## **Pynes Farm, planning application 20/00621**

Since we made our original consultee comments on 22<sup>nd</sup> of May there have been additional or revised documents for this application, including further comments by Ide Parish Council:

## 2. Revised elevation plan for eastern edge of site (overlooking the meadow).

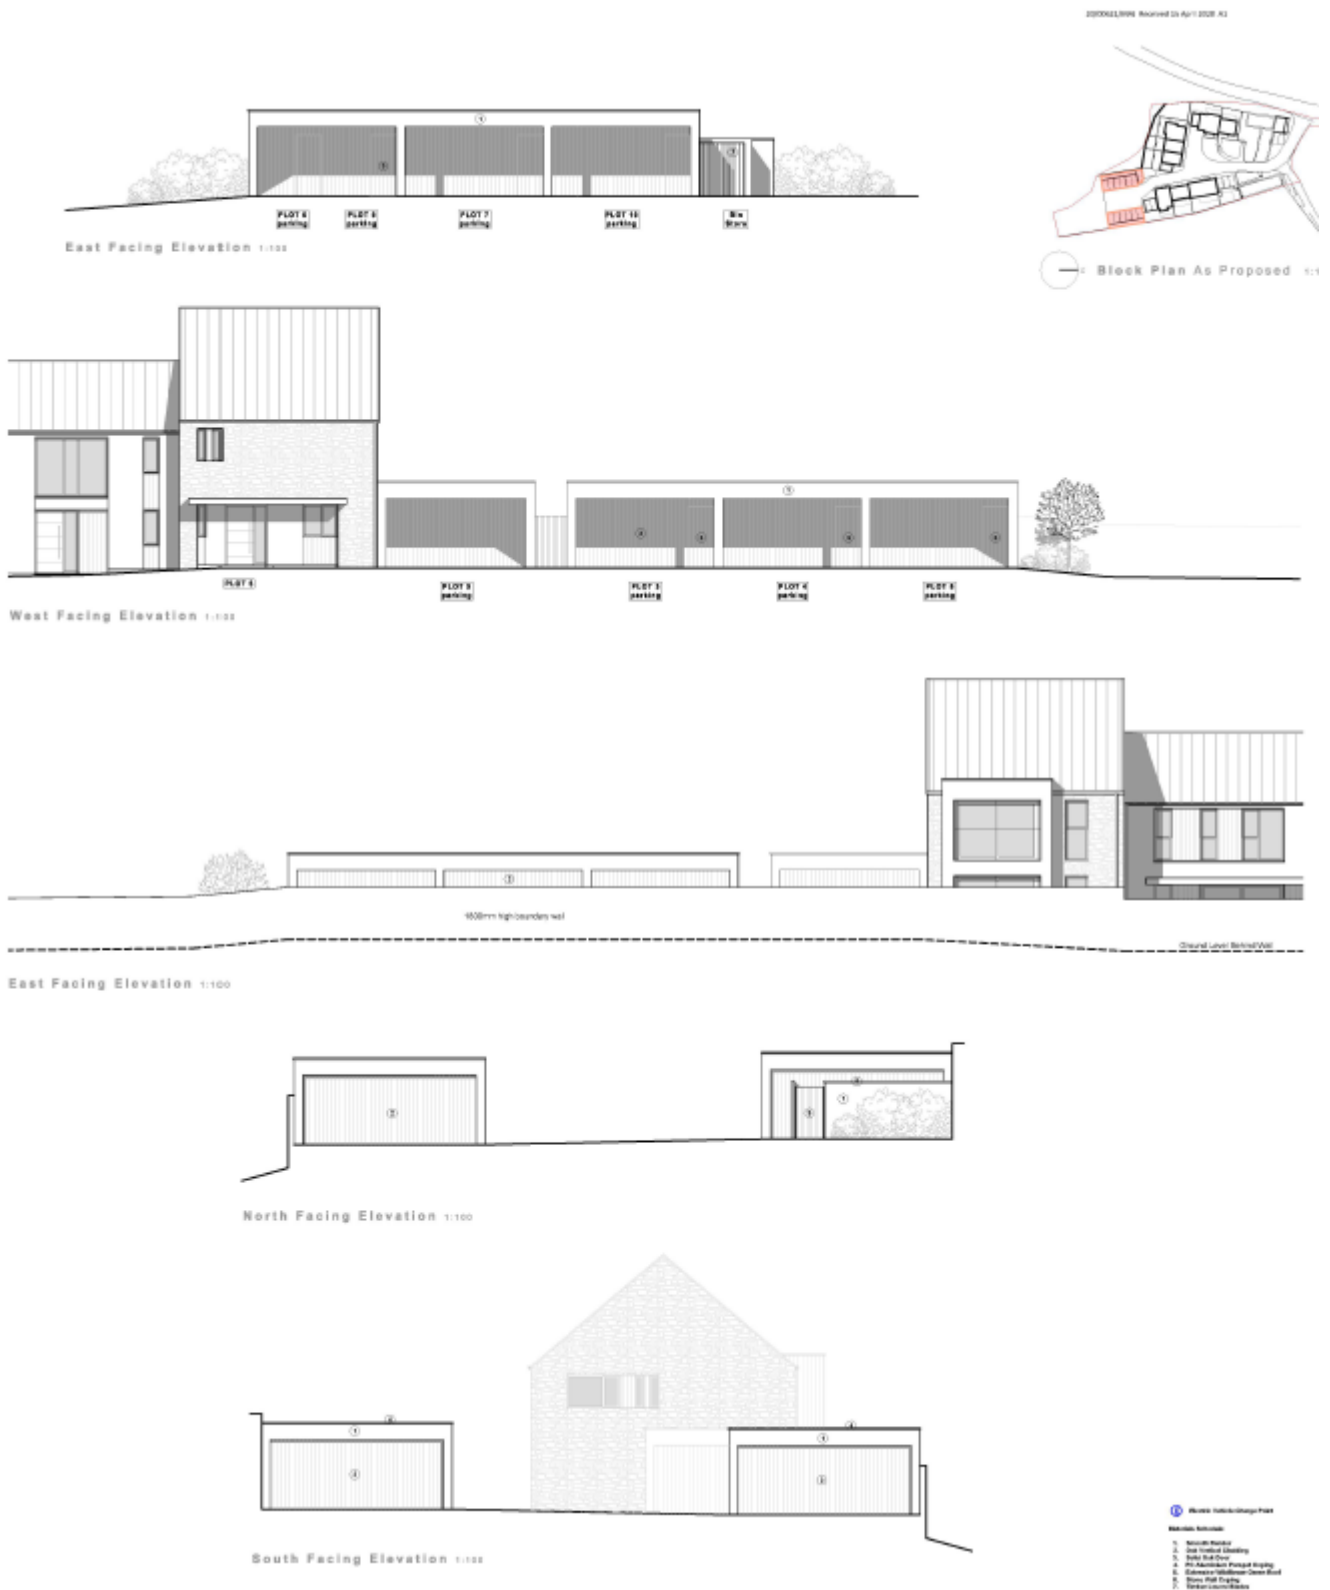
Revised design (in response to TDC ( and IPC ? ) comments:

## 4. Car port roofing design

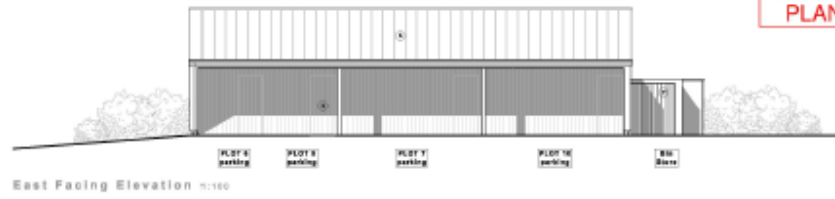
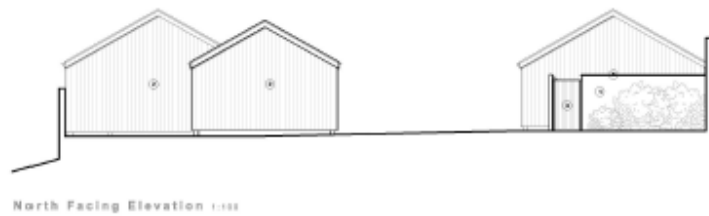
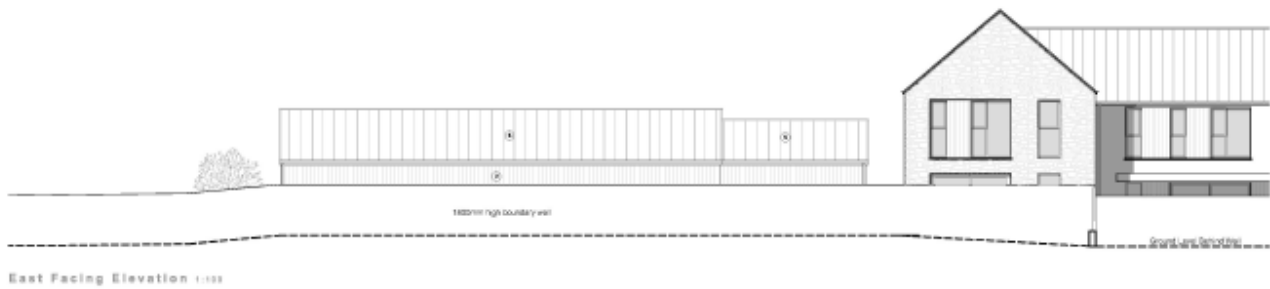
Original proposal was for flat roofs for car ports, revised to apexed roofs, TDC suggested otherwise.

Drawn	PW	25.02.2020	Scale	As Shown
Designed	PW	25.02.2020	File No.	102632-SK-REV-C.dwg
Checked	LC	26.02.2020	Drawing Status	For information
Approved	LC	26.02.2020	Drawing No.	102632-SK-001
			Revision	C

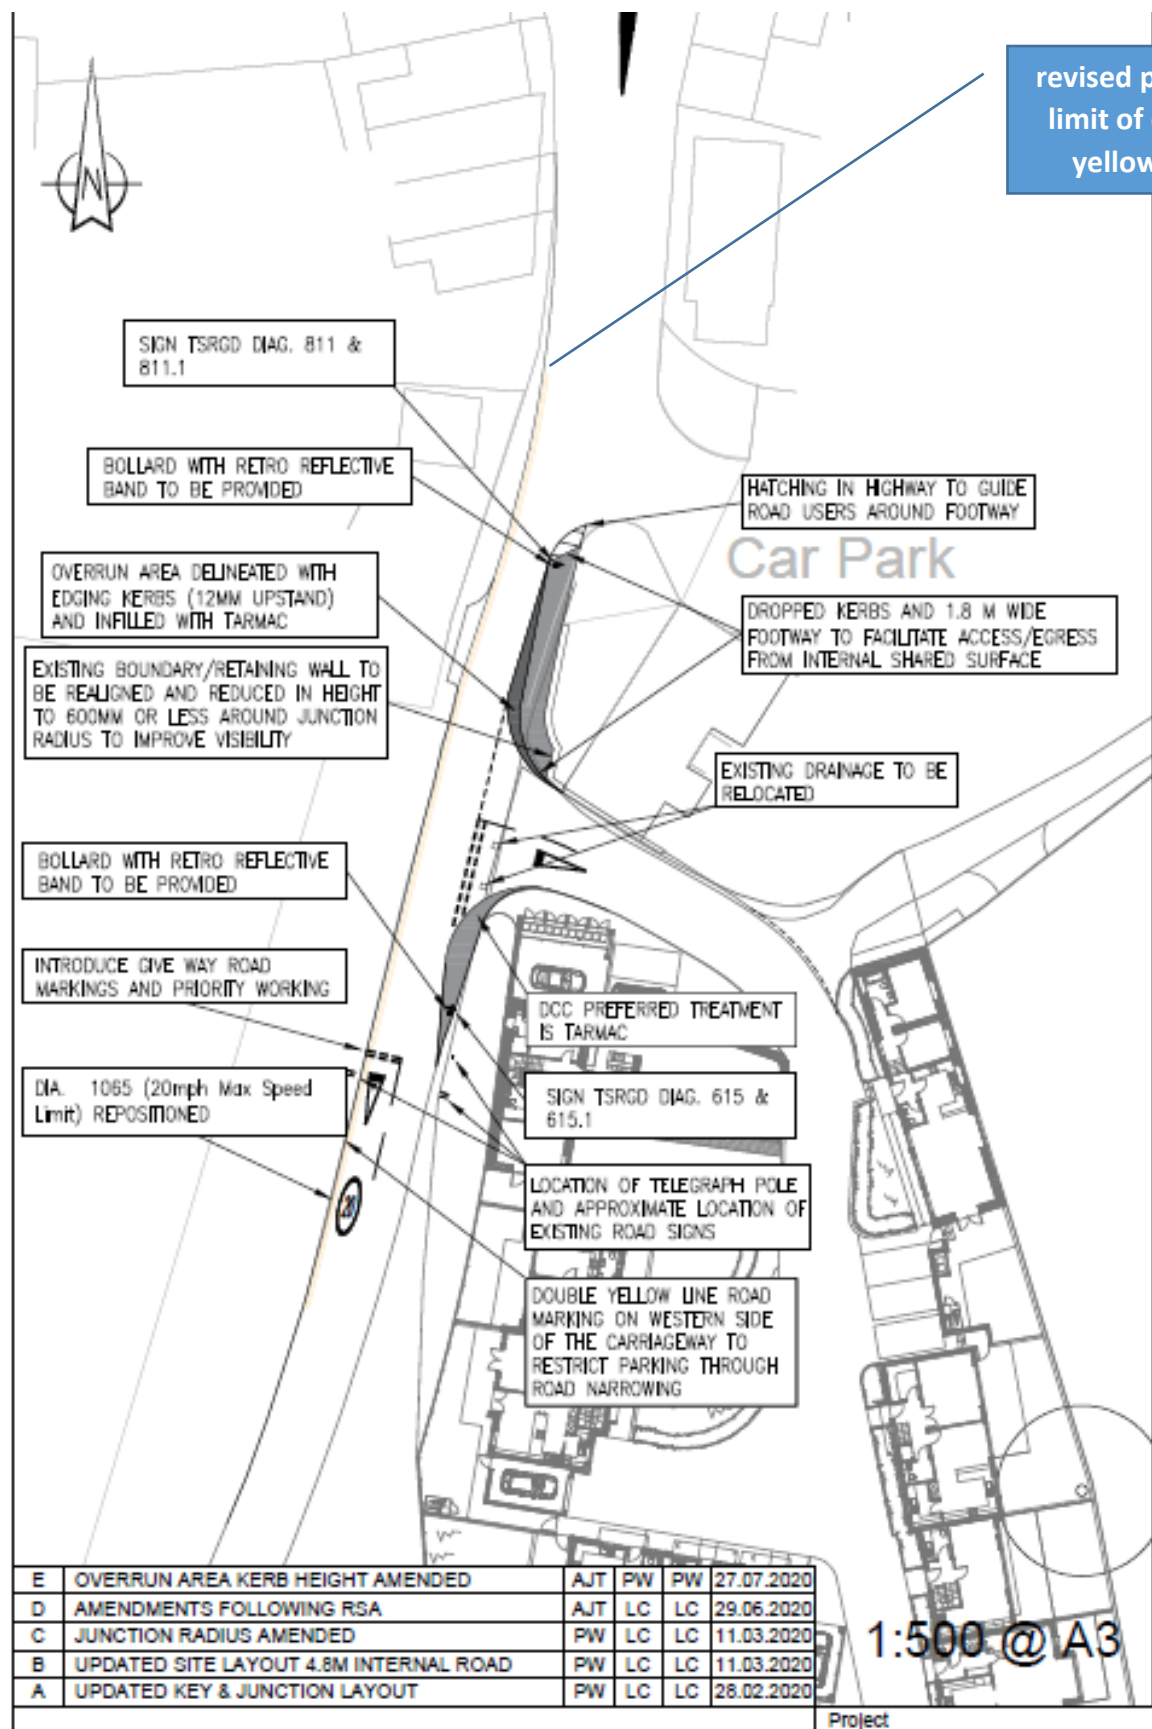
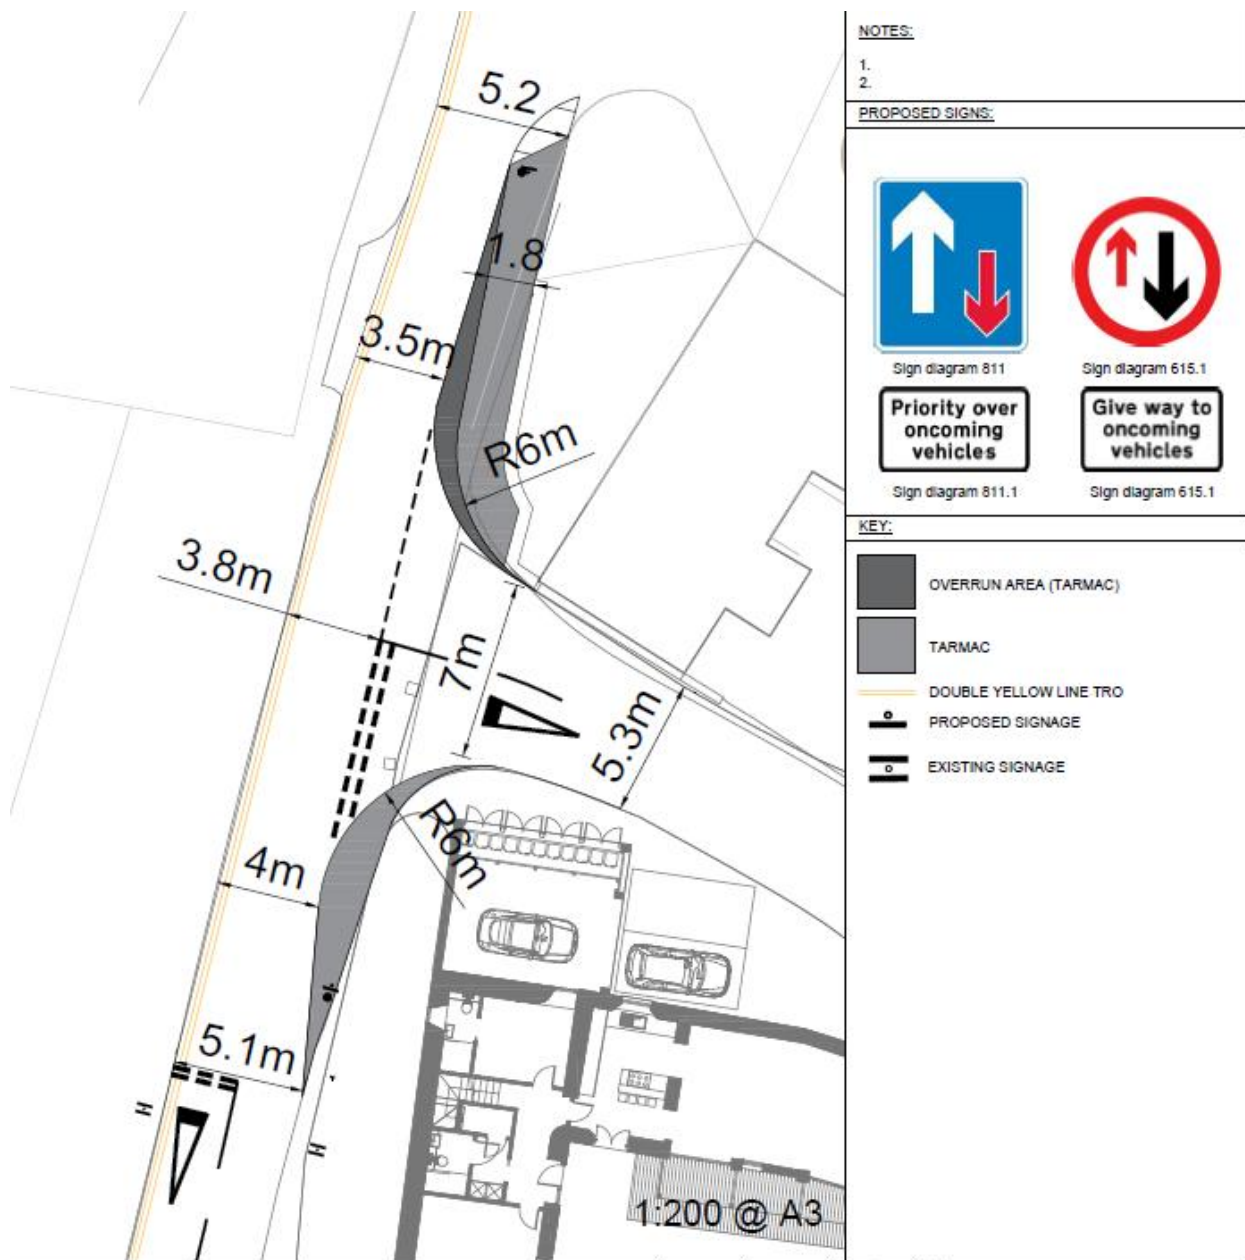
Key elements - double yellow lines to extend further down road opposite site, replacement of granite overrun area (below entry/exit, on eastern side of road) with tarmac, lowering of garden wall below site entry/exit. We have already commented on the revised transport plan, as detailed at start of document.

*We have noted and examined the revised transport plan. There are aspects which we feel are still not satisfactory from a safety and public amenity aspect.*

*We note the extension of double yellow lines opposite and down from the entrance to the proposed development, and the view that these might need to be extended further down the village. Please can it be emphasised that we would expect any lost parking spaces made good by the applicant as parking is a thorny issue within the village.*

*We do not regard the proposed revised road width of 3.5m sufficient for safety- the resident opposite the farm entrance has contacted me to advise that this would not allow them safe entry and exit from their property. In addition, the route up through the village to Haldon and countryside is heavily used by recreational cyclist and there are concerns over lack of overtaking space. Regarding buses, have the bus firm who service the Ide and beyond route confirmed their agreement that 3.5m is acceptable ? Relevant to all the issues raised in this paragraph is our understanding that Department for Transport guidelines suggest 4m width for such a road as that concerned.*

*The presence of reflective bollards is welcomed, but we agree with the view of Teignbridge that there need to be more of them.*
